APPENDIX I

Written Comments on the DEIS,
Community Board 5 and Manhattan Borough
President's Recommendations,
and Vornado Correspondence

15 Penn Plaza: CPC public hearing questions (5/26/2010)

15 Penn Plaza: Response to CPC Questions
(CPC Public Hearing: 5/26/2010)

ATTACHMENT 5b

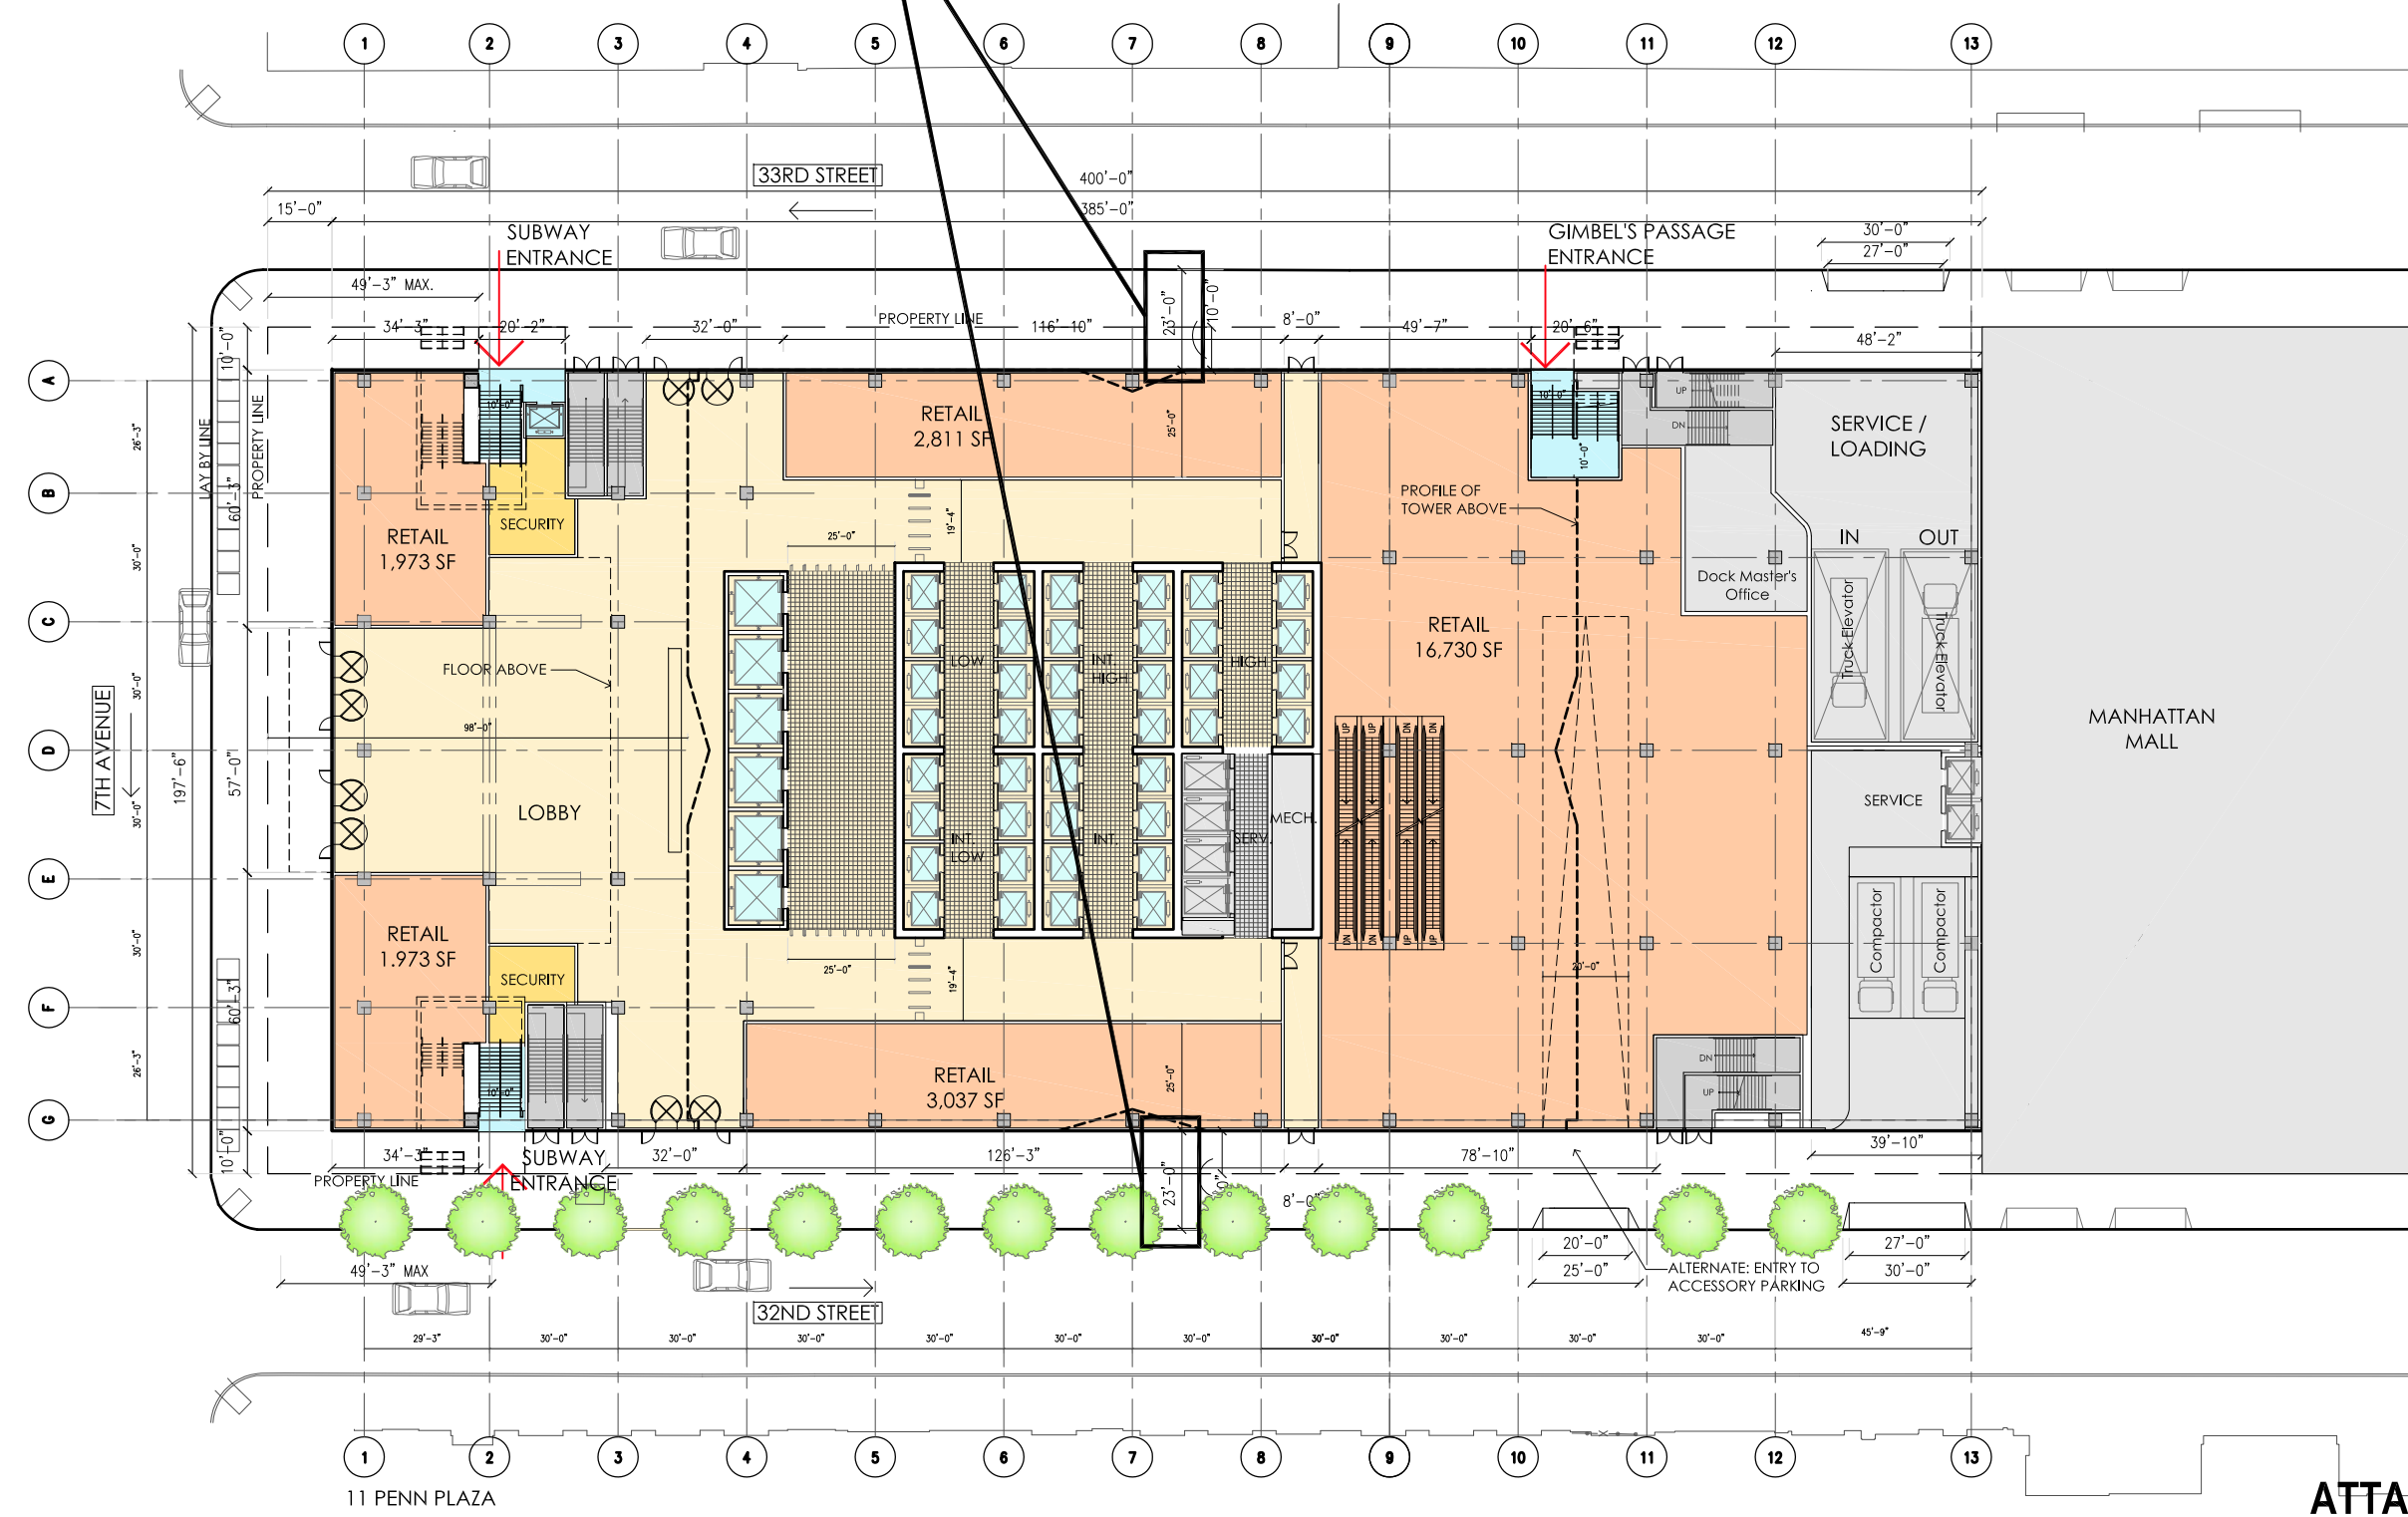
5. *A question was raised regarding floor-to-floor heights in both buildings.*
 - Attachment 5(a) shows the floor-to-floor heights at each level of the single-tenant building.
 - Attachment 5(b) shows the floor-to-floor heights at each level of the multi-tenant building.

FLOOR TO FLOOR HEIGHT
TYPICAL OFFICE	14'-6"
TYPICAL EXECUTIVE OFFICE	17'-0"
TYPICAL TRADING OR RETAIL	20'-0"
RETAIL	20'-0" ~ 26'-0"
MECHANICAL	25'-0" ~ 30'-0"

**EXISTING 33RD STREET PASSAGEWAY
SECTION 2
(LOOKING WEST)**

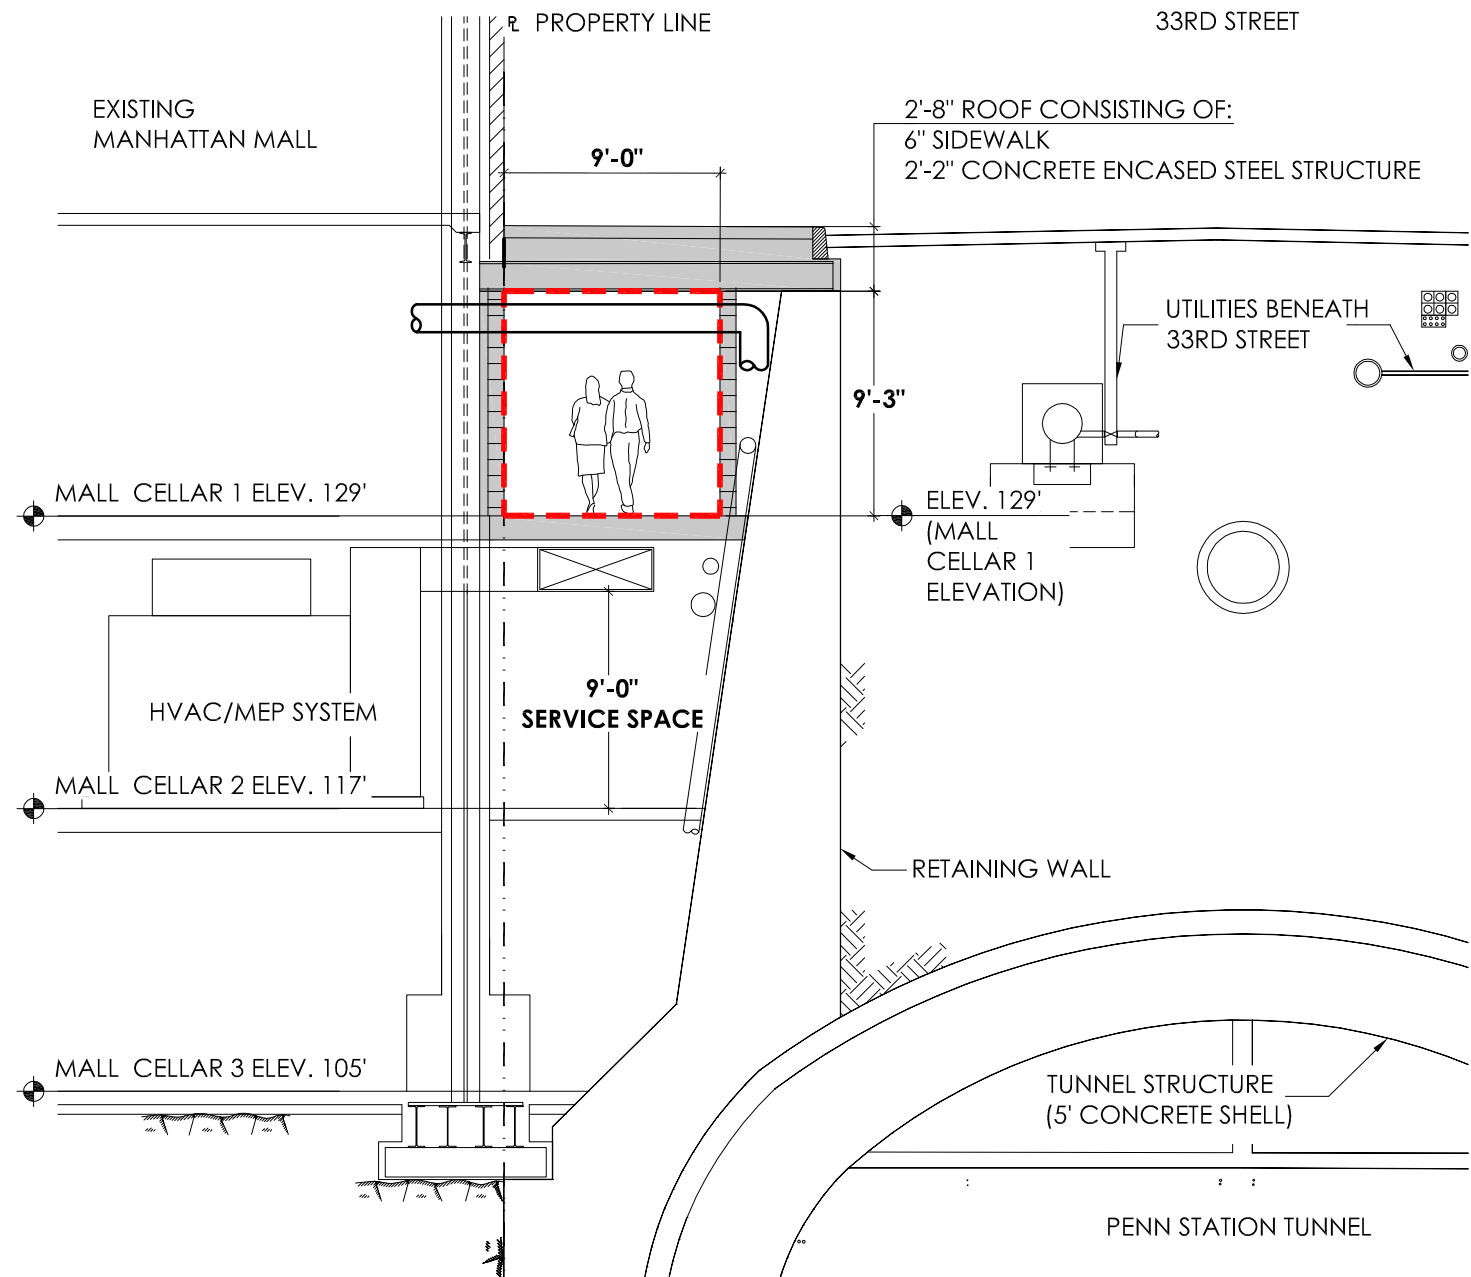
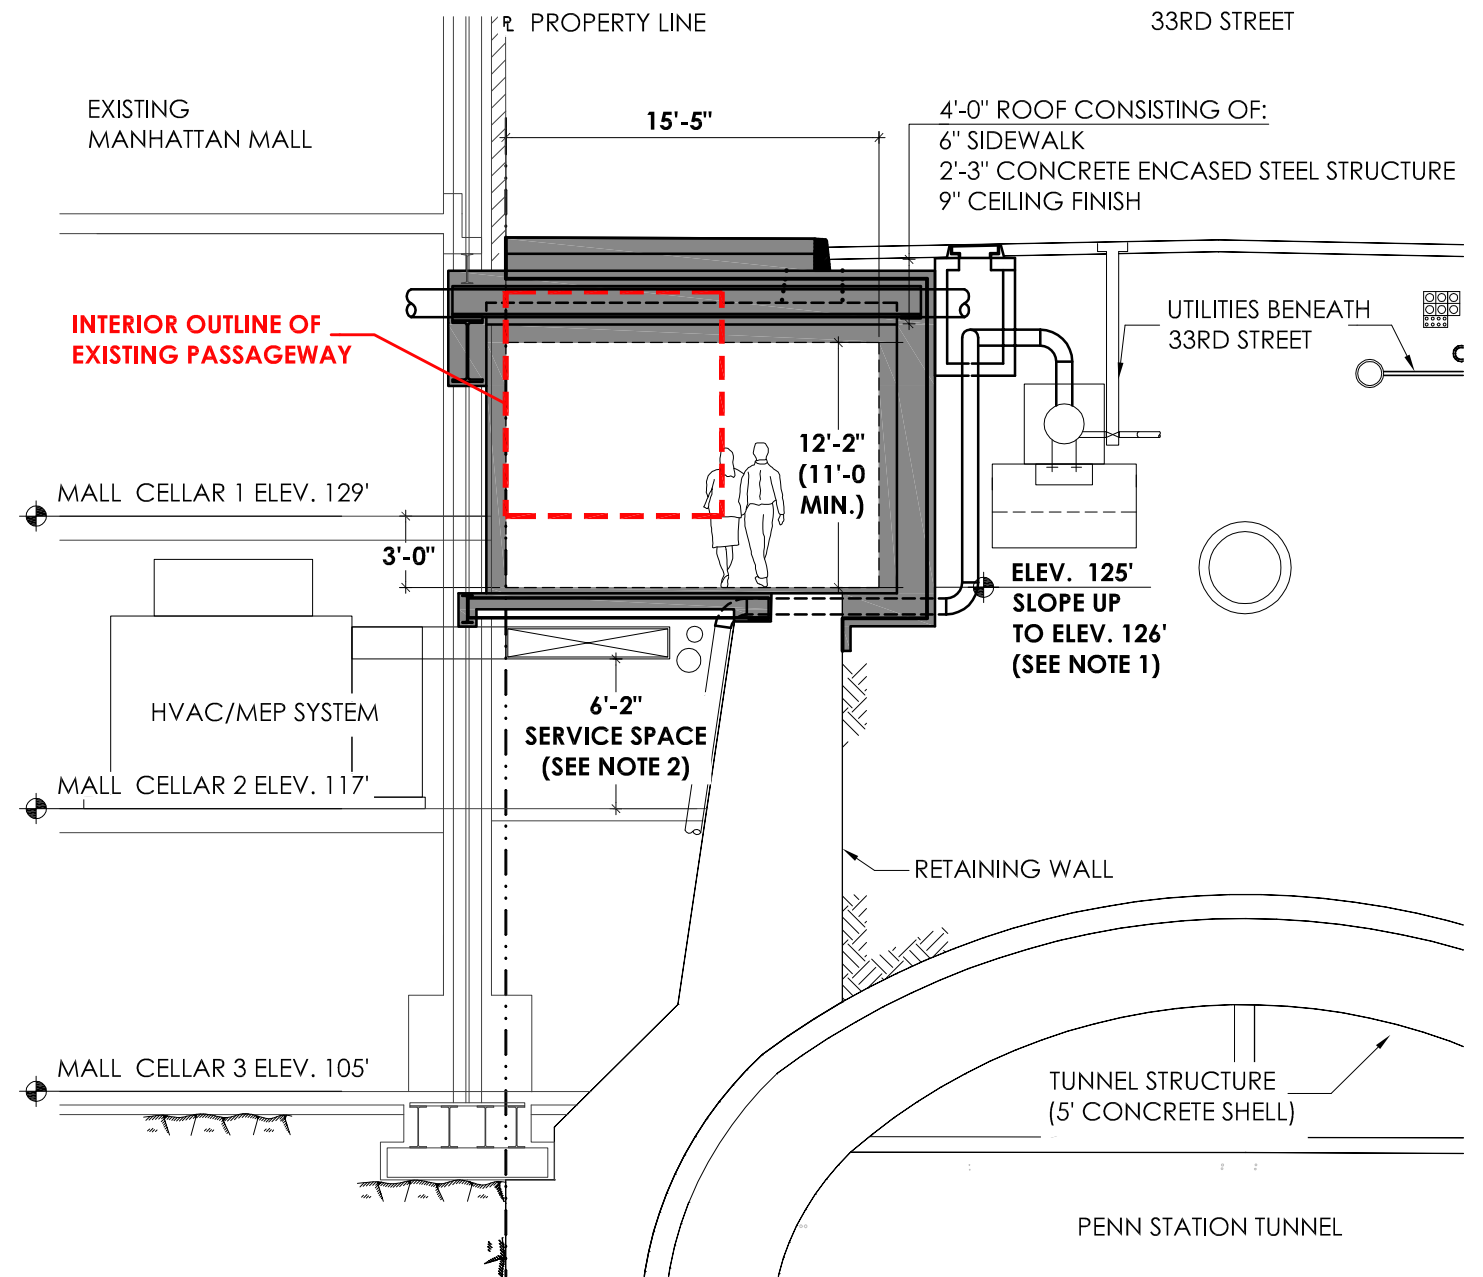
As requested, a plan of the passageway is provided in Attachment 1. Elevations detailing the north wall and south wall are shown in Attachment 2. Attachments 3 and 4 are sections showing the existing and proposed configuration of the passageway at both 15 Penn and the Manhattan Mall respectively.

- As a result of this change, the minimum height along the 15 Penn section of the passageway will now be approximately 13 feet, with a maximum height of over 14 feet.

1. ELEVATION DICTATED BY 7TH AVENUE IRT SUBWAY CONTROL AREA AND PLATFORM AT ELEV. 121.5'
